UNITED STATES PATENT AND TRADEMARK OFFICE

Office Action Summary	Application No. 10/734,030	Applicant(s) HOWELL, GLADE H.	
	Examiner QUYNH-NHU H. VU	Art Unit 3763

DETAILED ACTION

FIG-2

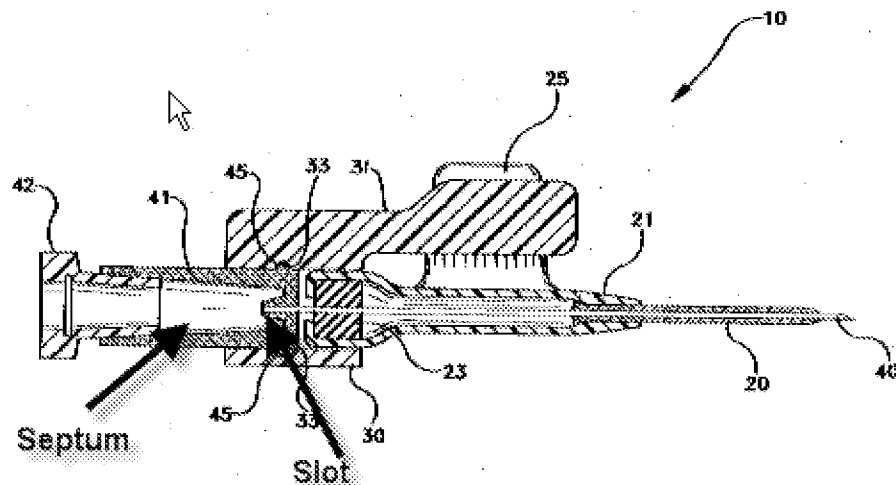
Brimhall '656 discloses a septum and needle assembly comprising: a needle 40 having a proximal end and a distal end; a housing; and septum (Fig. 2) disposed in the housing; wherein the needle is sliding disposed within the septum. A slit is disposed within the septum and the needle is sliding disposed within the slit (claim 2). A tube 50 attached to and in fluid communication with the housing (claim

3); a female adapter 51 attached to the tube (claim 4). Brimhall '656 does not disclose the needle defines a notch adjacent to the distal end.

Brimhall '554 discloses that a needle 16 having a notch 19 located adjacent to the distal end. Therefore, it would have been obvious at the time the invention was made to a person having ordinary skill in the art to modify the device of Brimhall '656 with an opening (notch like opening 19), as taught by Brimhall '554 in order to permit fluid to flow from lumen into annular space.

Regarding to limitation "a septum disposed in the housing and having a length greater than the notch distance". It is noted that it would have been an obvious matter of design choice to the septum having greater length than the notch distance, since applicant has not disclosed that limitation above solves any stated problem or is for any particular purpose and it appears that the invention would perform equally well with the prior art.
